PEPPERELL PAPER CO. DAM

MA 00373

PHASE I INSPECTION REPORT
NATIONAL DAM INSPECTION PROGRAM

NATIONAL PROGRAM OF INSPECTION OF NON-FEDERAL DAMS
DRAFT REPORT REVIEW COMMENTS

STABILITY

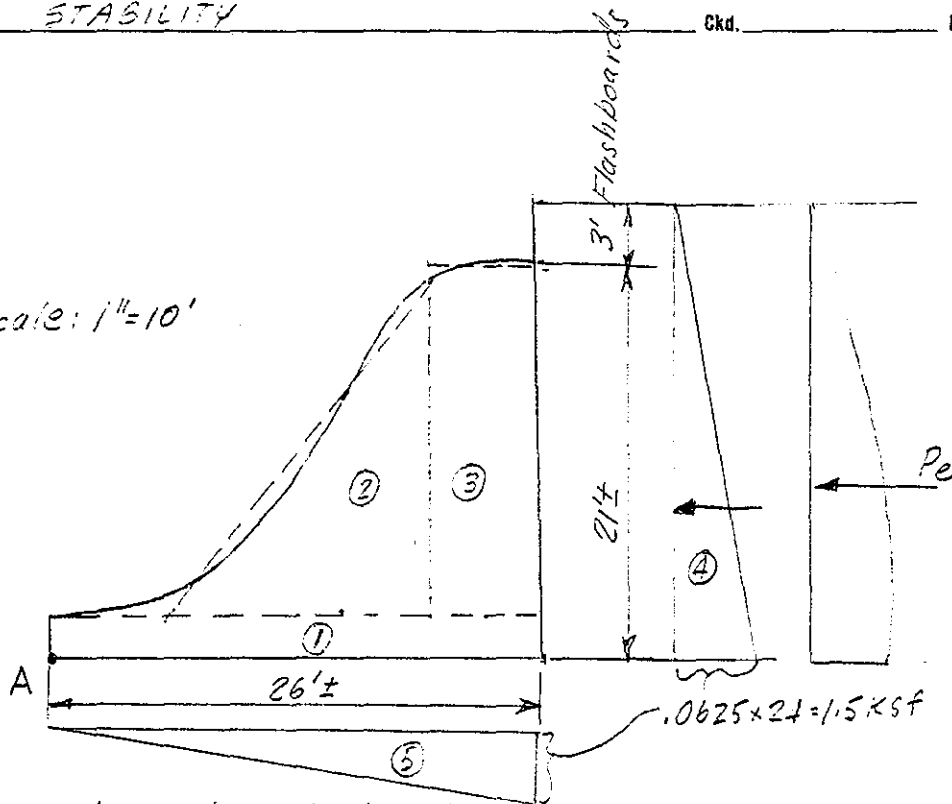
(14) Par 6.1 b. Delete reference to stability analysis.

Page No.	Comments
10	<p>① <u>Par. 7.2</u> - Only items involving additional engineering investigation or major modifications to the dam should be in this paragraph.</p>
	<p>② <u>Par 7.3a</u> Revise to "Not applicable"</p>
	<p>③ <u>Par 7.3b</u> Add any of the items now in 7.2 which do not require engineering investigation and warning system.</p>
App. B	<p>④ Delete reference to stability analysis</p>
